Amendment No. 1

Generation Interconnection Agreement

LCRA Transmission Services Corporation

West Texas Energy Wind Partners, L.P.

EXHIBIT "C-1" ONE LINE DIAGRAM

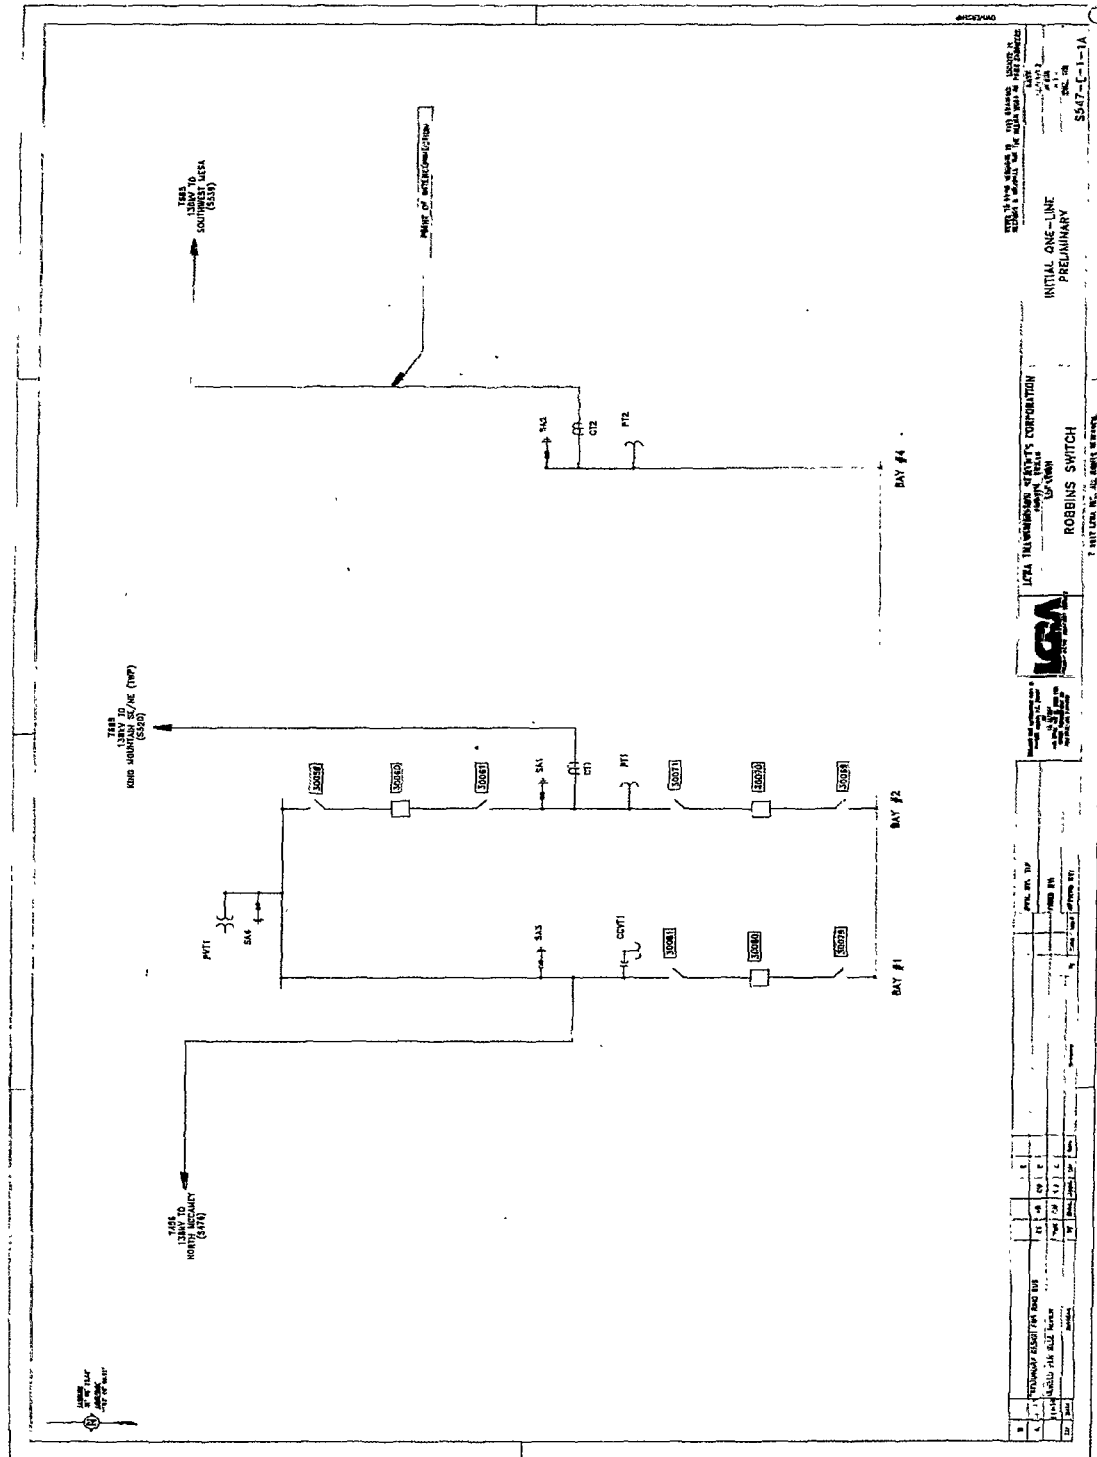
WHEREAS, this amendment to the Interconnection Agreement is necessary because the TSP will install 138-kV circuit breakers to increase transmission service reliability at the Robbins Switchyard and the description of the LCRA TSC Transmission Interconnection Facilities (TIF) requires updating; and

WHEREAS, the ERCOT Polled Settlement metering will be relocated from the plant to the TSP's new switchyard at Robbins Switchyard Substation.

2. Exhibit "C" Interconnection Details (including the diagram Exhibit "C-1" and "C-2" attached thereto), attached to this First Amendment, will become effective upon execution of this First Amendment by the Parties.
